NOTICE
Village of Roberts
Plan Commission Meeting
Thursday, March 3, 2022
7:00 PM
GoTo Meeting Information below for online access
Agenda

To: Roberts Plan Commission

Re: Concept Plan – Sharondale Multi Family (along STH 12) – Alex Miller

Re: T-Buck Inc (east of STH 65) – Concept Plan Private versus Public Streets

CONCEPT SITE PLAN

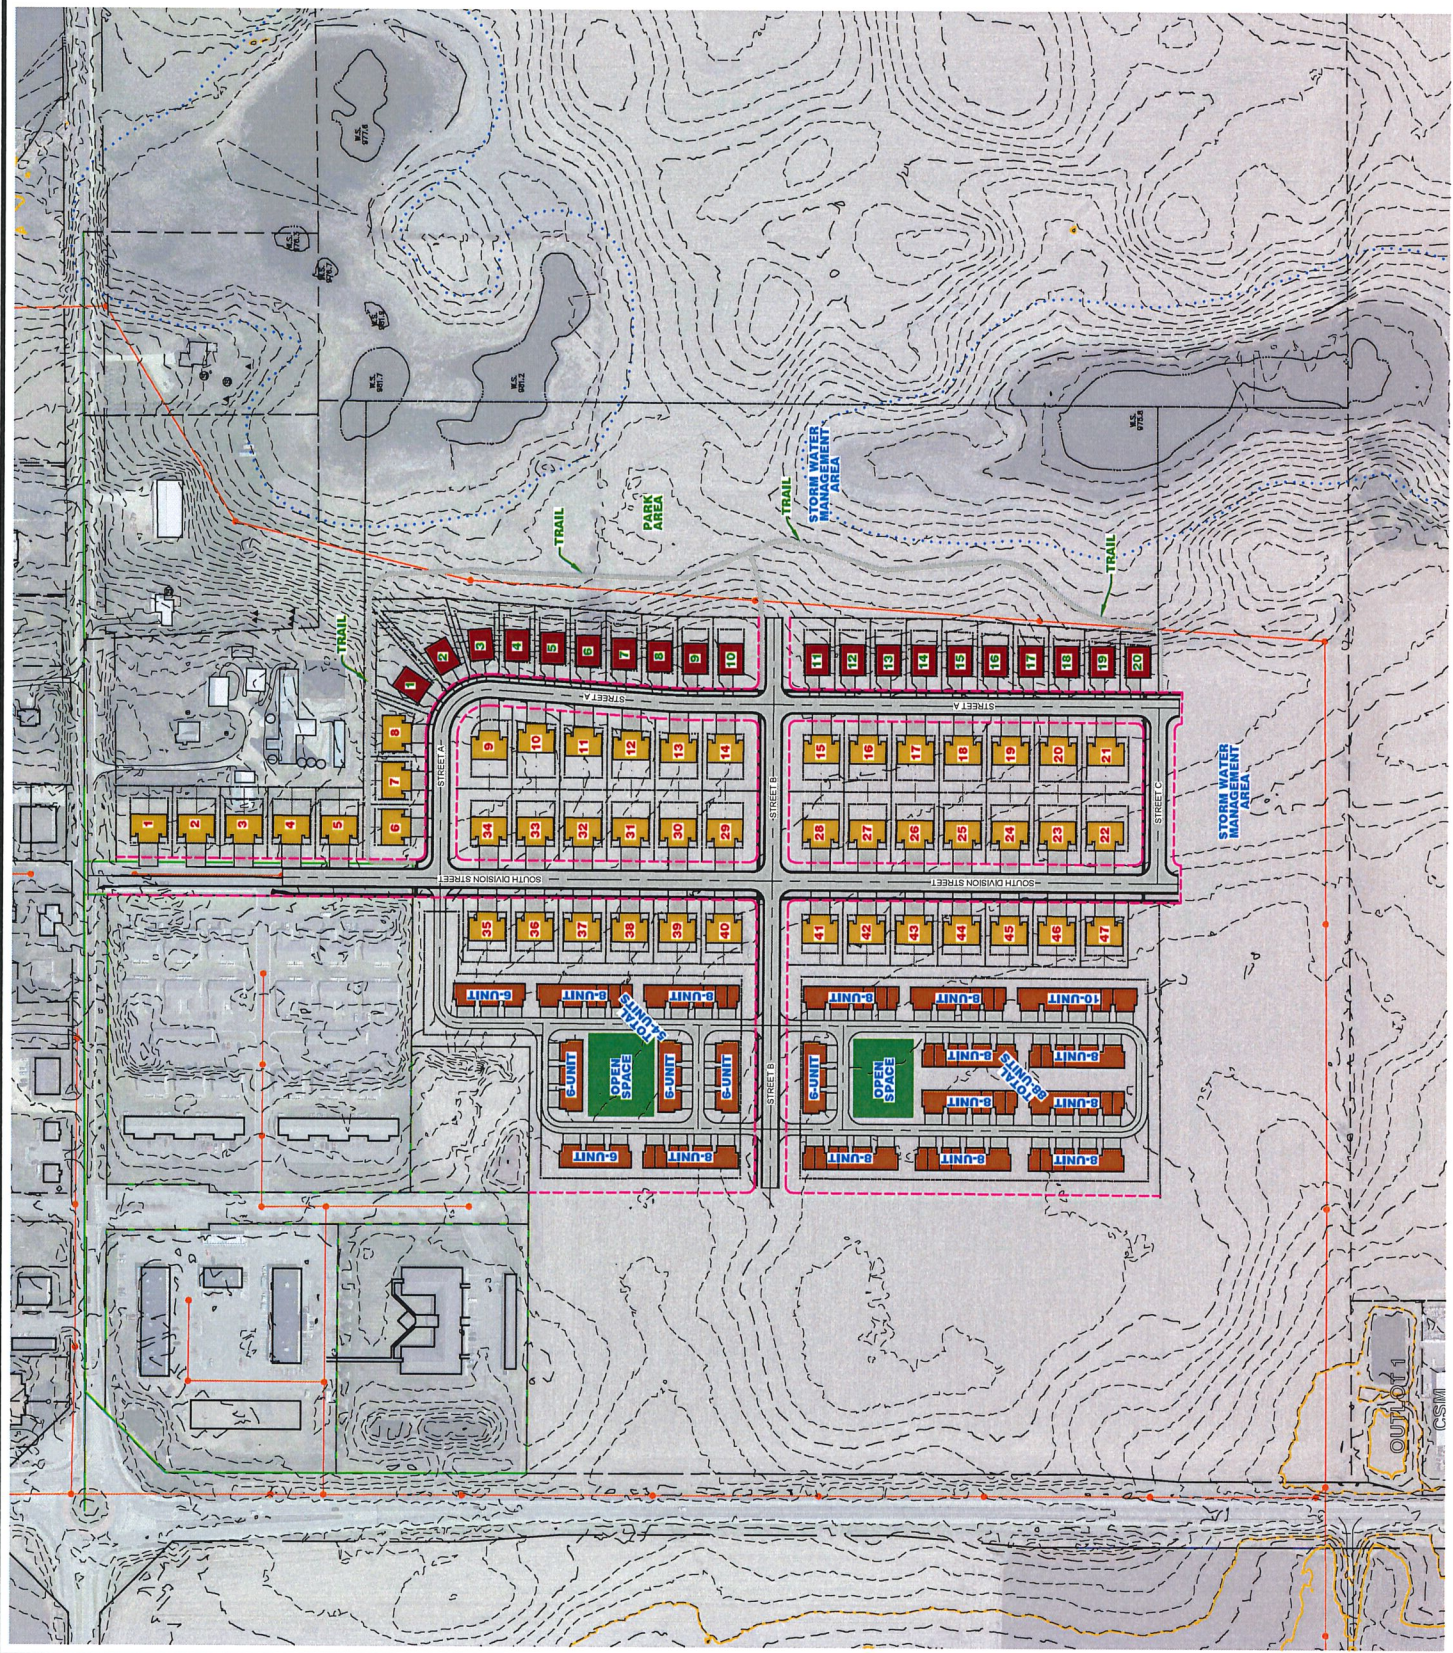
Proposed concept plan includes (6) 4-plex buildings and (2) 8-plex buildings, for a total of 40 units. Lots are 1-acre, 1-acre, 1-acre, and 2-acres. **Developer may be combining two west 1-acre parcels to a single 2-acre parcel, as then setback variances would not be needed.** Parcels are in Village limit, currently zoned Rm-2, Multi-Family Residential.

With combining two west parcels, site plan can meet the typical 24-foot drive lane between two 18-foot parking stalls, or 60-foot garage-to-garage distance required for turning movements.

| SHEET NO. 1 OF 1 | PROJECT: T BUCK, INC. MILLER CORNER VILLAGE OF ROBERTS, ST. CROIX COUNTY, WISCONSIN | |  Auth-Consulting/associates |  S&N Land Surveying | DRAWN BY: DJZ | | | | | |

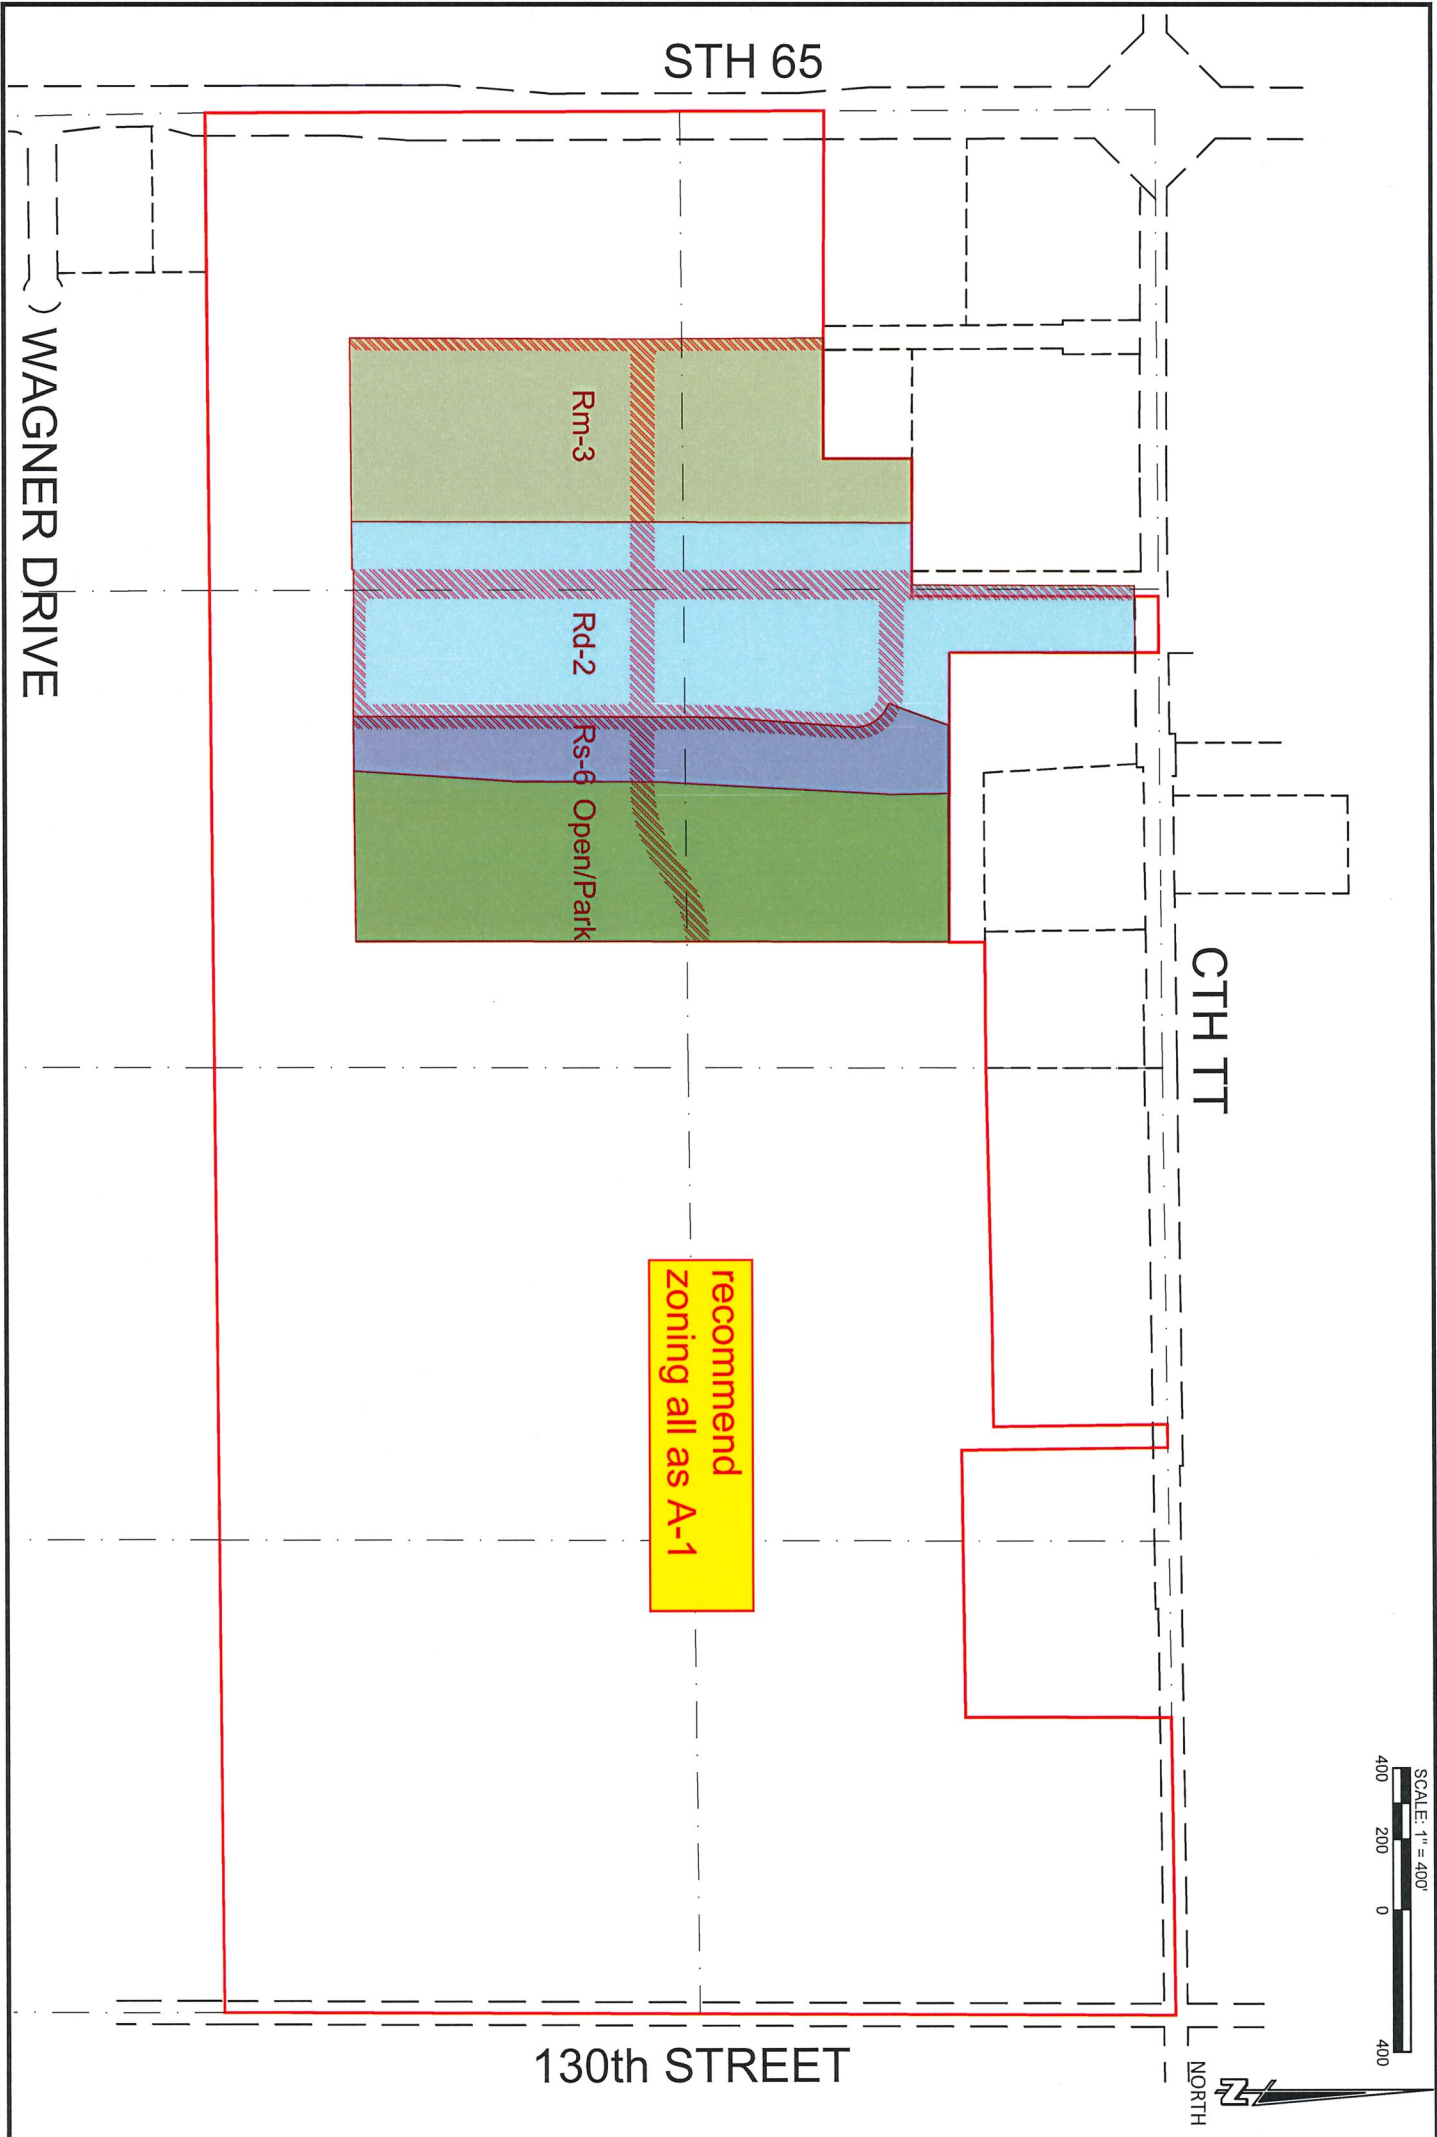
Multi-Family Residential, Rm-3, is shown as one lot with 54-units and one lot with 88-units, with 24-foot-wide private streets. Developer has noted that would like option to subdivide to individual lots and extend public utilities through private streets.

- If public utilities and/or public water metering and/or separate lots are created for individual units/building, recommend that streets are 66-foot R/W public streets that front each lot.
- Fire Department Input (safety and access concerns, public vs private hydrant concerns)
- Police Department Input (safety concerns)
